Schedule of Community Submissions – Proposed Amendment No. 2 to Burswood Lakes Structure Plan

Schedule of Referral Agency comments – Proposed Amendment No. 2 to Burswood Lakes Structure

Figure 3: Shadow Analysis Diagram. Summer Solstice – December 21 – 3:00PM

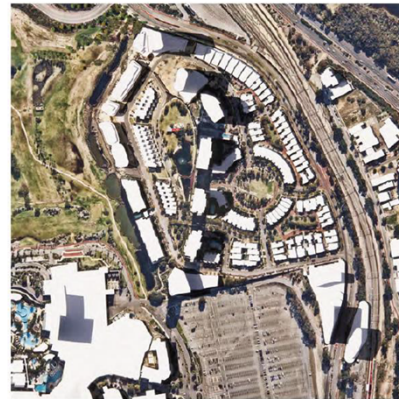
A revised shadow analysis has been prepared to demonstrate the impact of the increased building height, plot ratio and setbacks proposed on Lot 1. The shadow study illustrates that during the winter solstice the single dwellings to the east are unaffected, however during the summer solstice at 3:00pm the majority of Lot [information redacted] Bow River Crescent will be cast in shadow, this includes all north openings to habitable rooms which is critical to the dwelling design due to the zero allotment to the east. It is acknowledged that the shadow analysis has informed the envelope of Lot 1, however Lot [information redacted] is detrimentally impacted.

- Reconsideration of the building envelope to Lot 1 to seek to modify the shadow analysis to mitigate the impact to Lot [information redacted] Bow River Crescent;
